Case Number DDO-21-18

DESIGN DEVELOPMENT OPTION (DDO) APPLICATION For Landscaping/Screening Substitutions

City of Tucson Fire Station 15 - Project Description

DEVELOPMENT PACKAGE FOR ADDITION TO FIRE STATION 15 CITY OF TUCSON 2002 S MISSION RD TUCSON, AZ 85713

1 SITE PLAN
SCALE: 1"=30'-0"

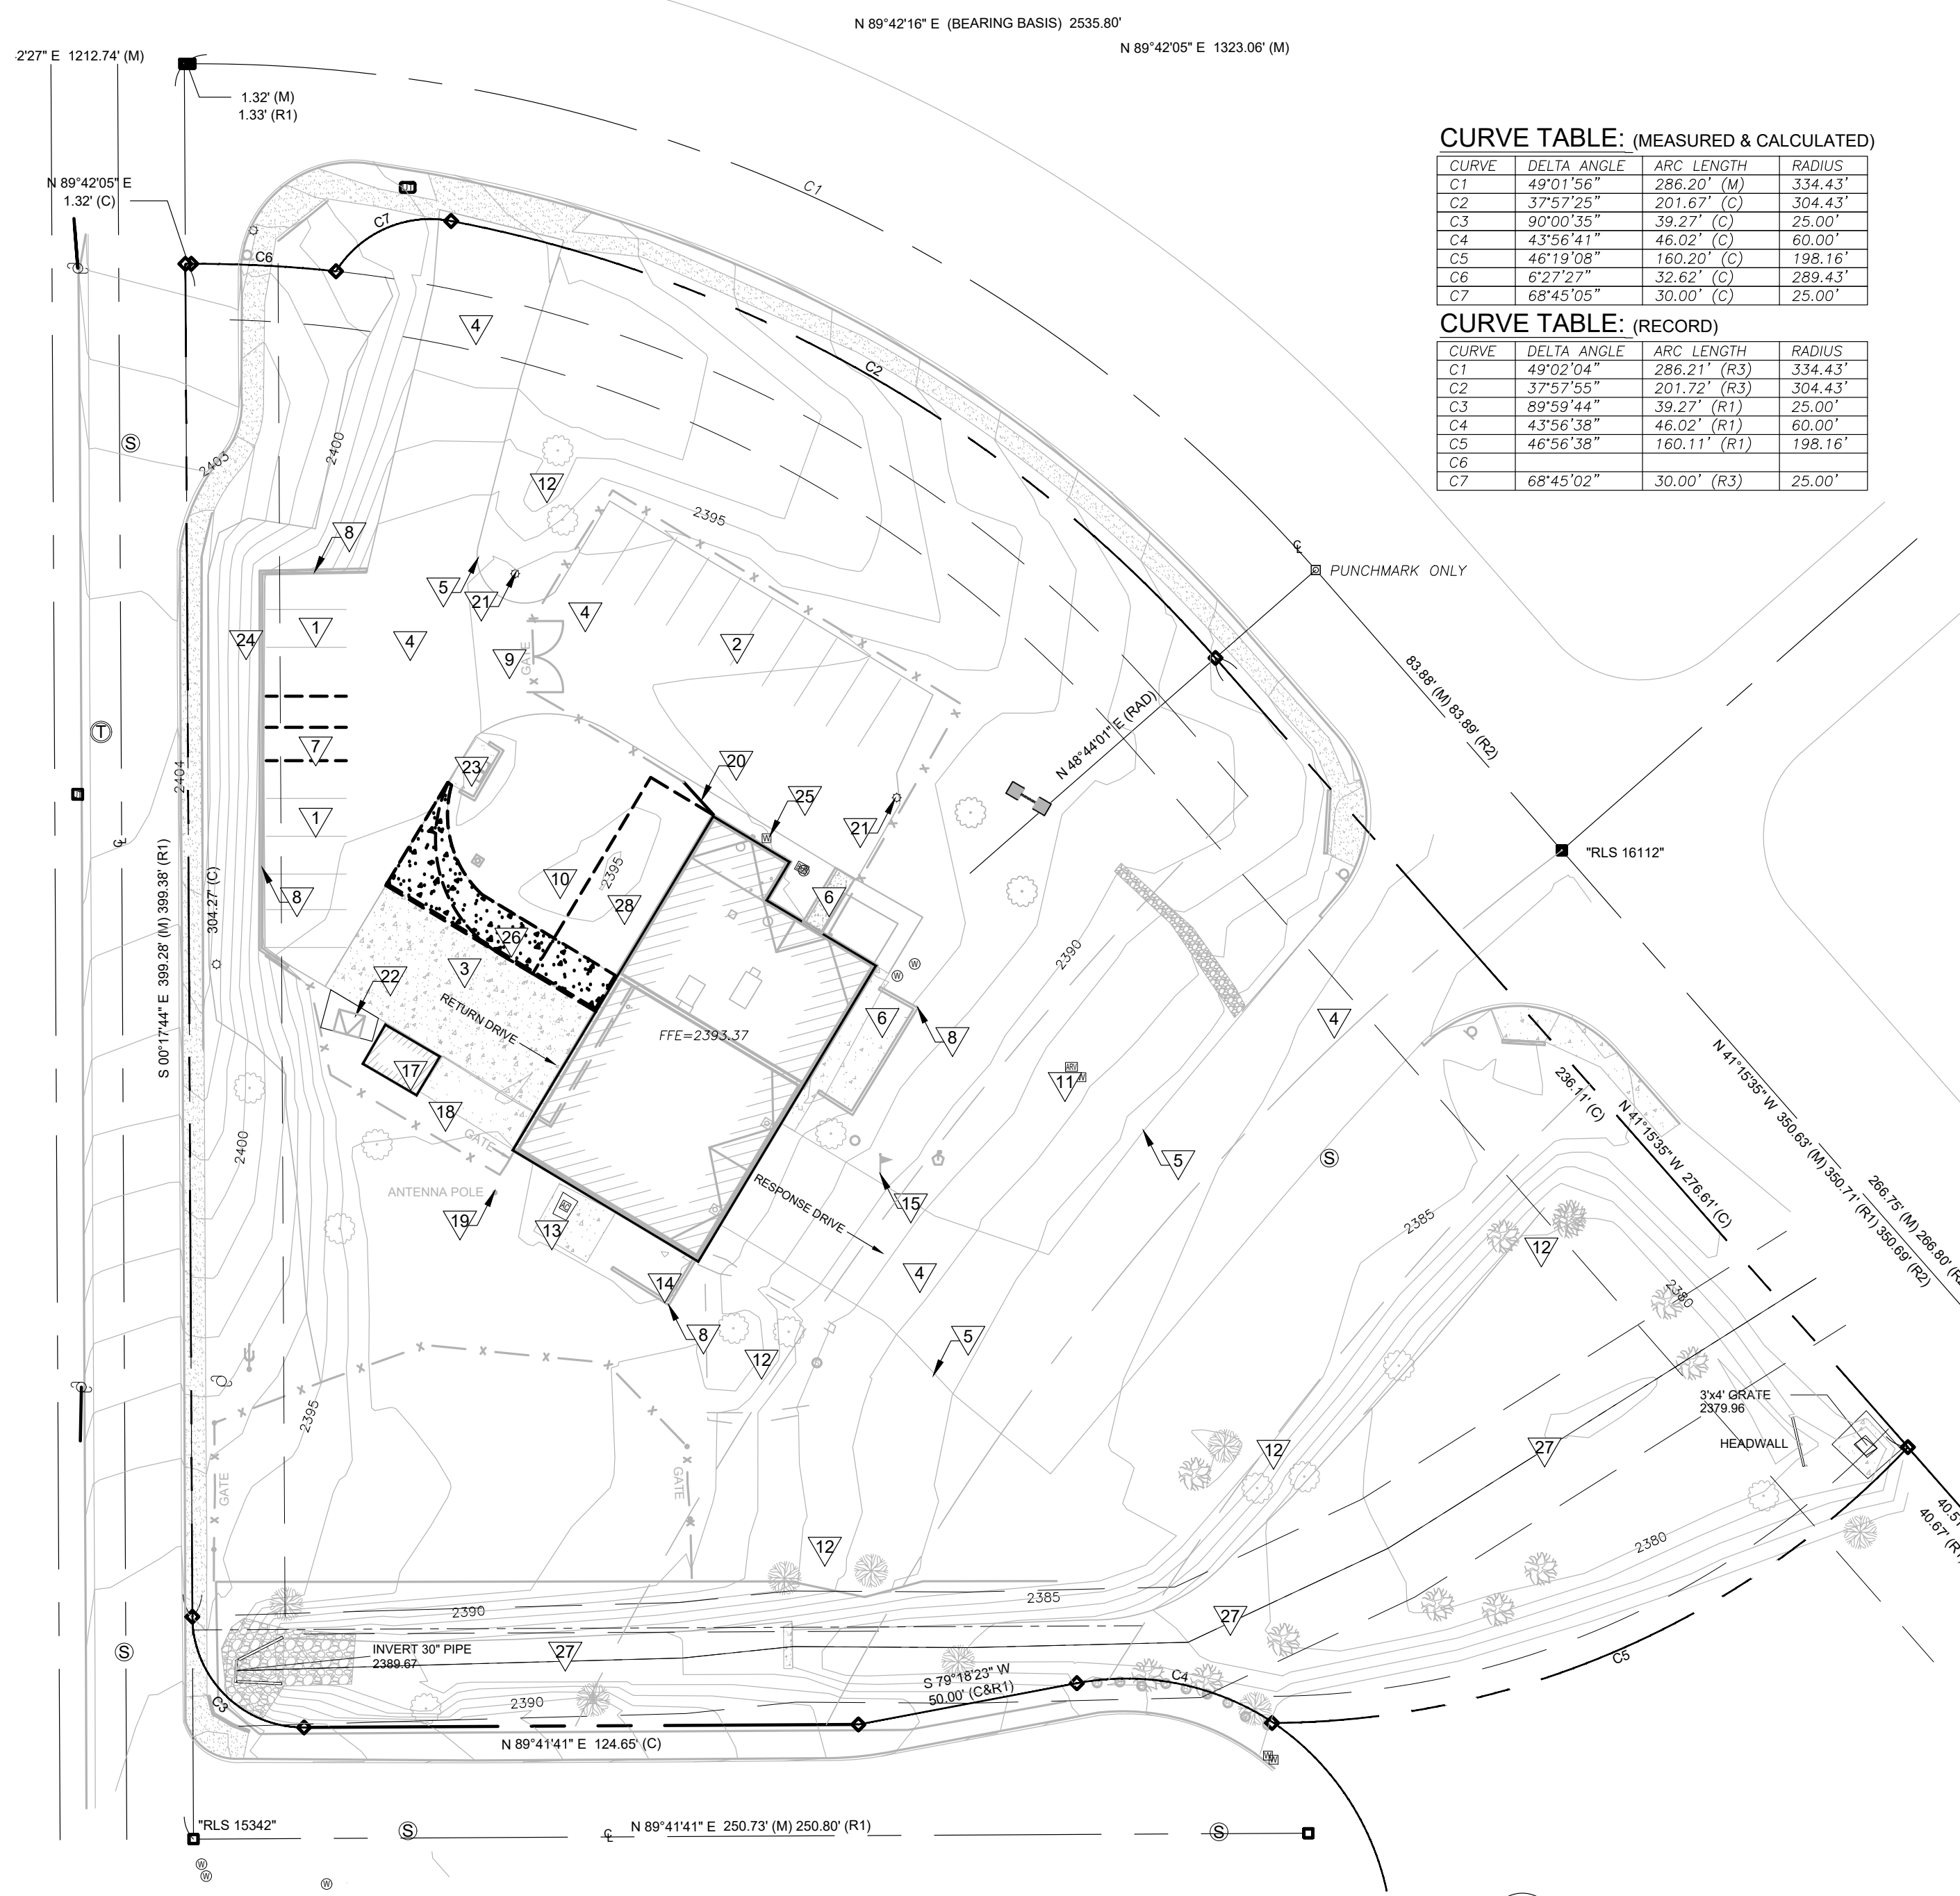
3. 2-06.4.4.B – In the location map on sheet 1, identify all streets that abut the subject property

4. 2-06.4.7.A.4 - Identify the existing and proposed use of the property as classified per the UDC. List all UDC sections applicable to the proposed uses. Demonstrate compliance with use-specific standard 4.9.13.F. which requires a minimum 5 ft screen wall on the portion of the site abutting a residential property. This must be a solid, opaque wall, unless modified through a variance (deletion of the requirement) or constructed of another material (chain link and slats) and modified through a Design Development Option (DDO), which is an administrative process. The DDO request would be for a substitution of materials to include slatted chain link fencing and vegetation in lieu of a solid wall. Contact Mark.Castro@tucsonaz.gov for more information on either of these options.

5. 2-06.4.7.A.8.a, b, c – Update general notes on sheet 1. Include existing storage building on west of property, which appears to be approximately 150 sq ft. Update notes on floor area for each building, Percentage and area in square feet of building and accessory building coverage, and Percentage of building, lot area, or vehicular use area expansion.

9. 2-06.4.9.H.5.a - Show all motor vehicle off-street parking spaces and parking areas, fully dimensioned. A typical parking space detail shall be provided for both standard parking spaces and those for the physically disabled. For information on parking requirements for the physically disabled, refer to adopted building and accessibility codes of the City of Tucson. Design criteria for parking spaces and access are located in Section 7.4.6, Motor Vehicle Use Area Design Criteria, of the UDC. Correct site plan keynote 30 and accessible parking note on sheet 1 and detail 3 on sheet 2 to align. Different dimensions are provided and one note states "non-compliant".

10. 2-06.4.9.H.5.a – Correct notes regarding calculations on the number of parking spaces required (include the ratio used) and the number provided, including the number of spaces required and provided for the physically disabled. Parking is based on gross floor area of all structures, including the existing storage building. Please note, GFA does exclude vehicle use area (garages). Based on rough calculations, it appears approximately 9-10 parking spaces are required. Please verify this calculation and correct on the site plan.

11. 2-06.4.9.H.5.d – Clarify location of the two short term bicycle spaces which are required.

12. 2-06.4.9.O - All applicable building setback lines, such as erosion hazard, floodplain detention/retention basins, and zoning, including sight visibility triangles, will be shown. Correct setbacks (lines and general notes) for San Juan Tr, San Antonio Dr, and Placita Del Jubilo. As San Juan Tr is a Major Street and Route, developing area setbacks are applied to all streets as found in UDC Article 6.4.5.C.2. Setback from San Juan Tr is 21 ft or the building wall height (whichever is greater) as measured from the back of future curb. Setback from San Antonio and Placita Del Jubilo are 21 ft or the building wall height (whichever is greater), as measured from the outside edge of adjacent travel lane.
